**EMBREY BUILDERS, LLC.**  
 1020 N. E. Loop 410, Suite 700  
 San Antonio, TX 78209  
 Ph: (210) 824-6044 Fax: (210) 824-7656

RFI

To: Jordan & Skala Engineers, Inc. RFI #: 4  
 14240 Midway Road, Suite 350 Date: 12/1/2011  
 Dallas, TX 75244 Job: EB-02 Keller Springs Lofts  
 Ph: 469/385-1616 Fax: 469/385-1615 Phone: 877-777-5115

CC: Erik Earnshaw (BGO)  
 Subject: RFI #4  
 Drawing: sheet 5.3 arch m3.5c Spec Section:  
 Cost Impact: None Schedule Impact: None

Printed Date: 12/7/2011  
 Job: 2011-12-07 15:47:48  
 Product Type: Gravity  
 Mark: Mark 1

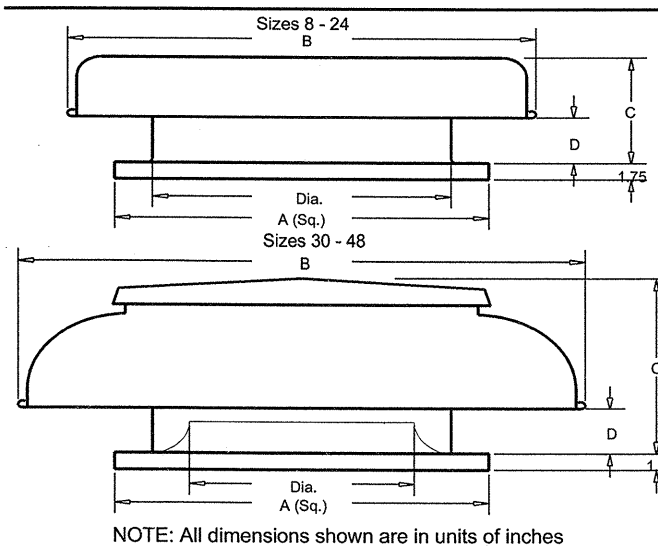
**Request:** Date Required: 12/8/2011  
 JSE Please verify that 72"x18" will work for the smoke relief louver size.  
 BGO does the 72"x18" louver does this need to be pressure relief on top according to bgo plans sheet 5.3 or smoke relief on m 3.5c  
**Requested by:** Bryan Pickler  
 Embrey Partners, Ltd.

**Response:**  
 Please see sheet 5.3 and 5.4 of the BGO drawings I would like the vent to be on top of the elevator shaft as is the intent of the drawings. Please see the attached cut sheet and the below narrative of this vent.  
 Greenheck  
 GRSR-24  
 min. 3sf of free area  
 motorized damper interlocked to the fire alarm system. Damper shall fail in the open position. Hinged roof curb for access to Damper  
 Erik Earnshaw  
 Answered by: BGO Architects Date: 12-12-2011  
 Company: Date:
